RESOLUTION NO. 28-1996

A RESOLUTION OF THE CITY COUNCIL OF THE CITY OF ABILENE, TEXAS AMENDING THE SIDEWALK MASTER PLAN.

EXHIBIT "A"

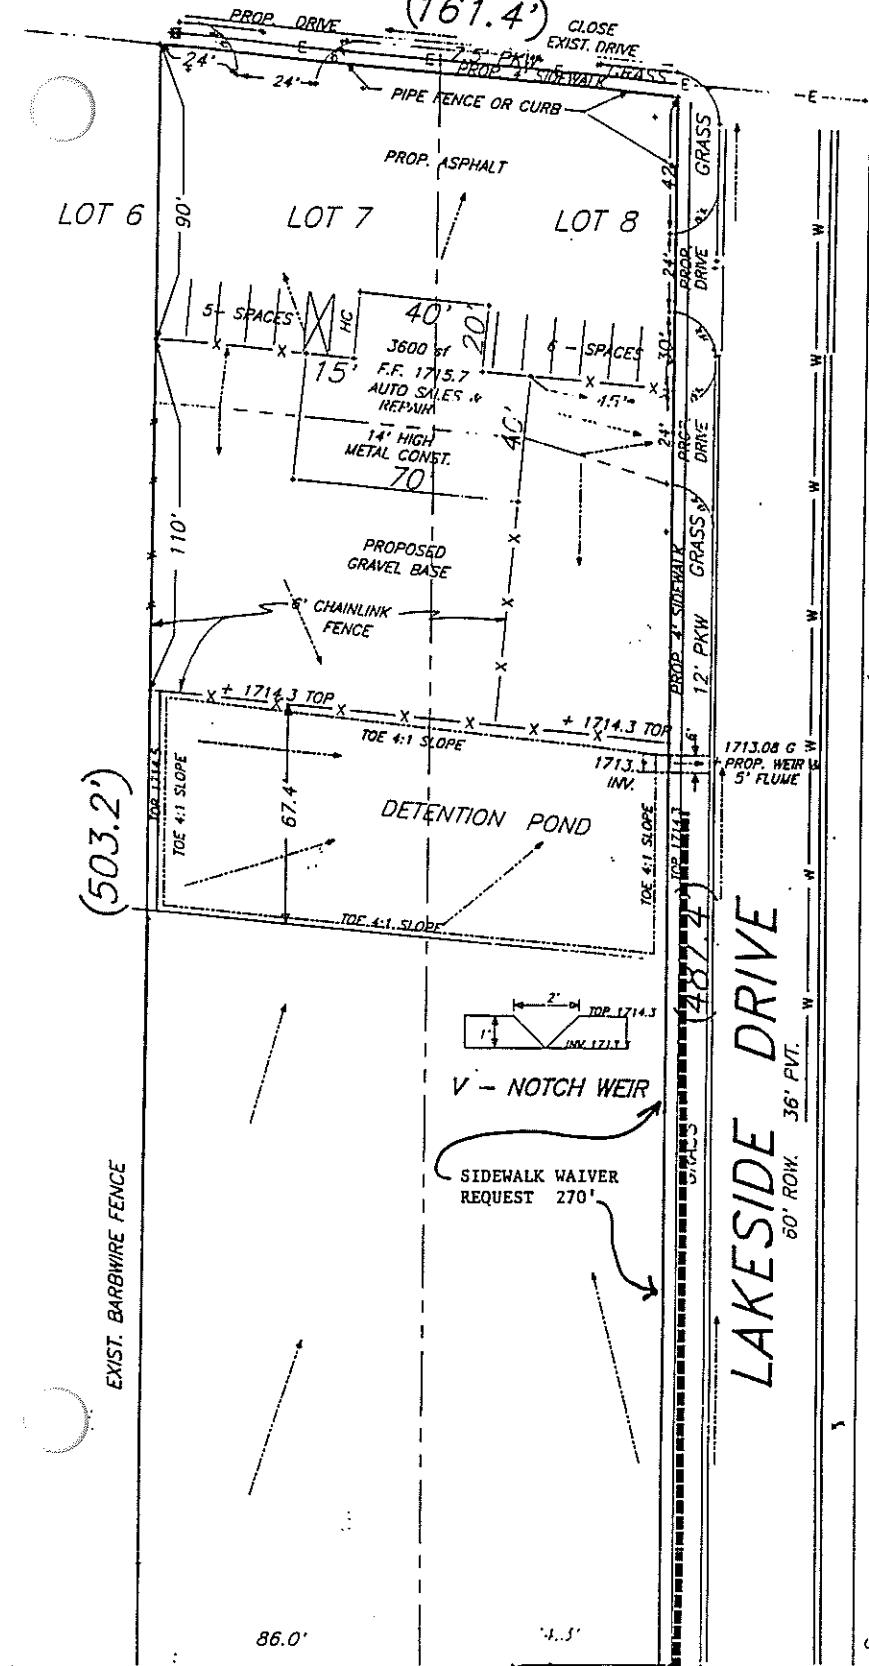
PART 1: That the document consisting of text and map entitled "Sidewalk Master Plan" be amended to waive the requirement for a sidewalk along the east side of the 1100 and 1200 blocks of Lakeside Drive as indicated on Exhibit "A", while it is not improved, provided that if the property in question is improved in the future, a sidewalk will be required as indicated in the Sidewalk Master Plan.
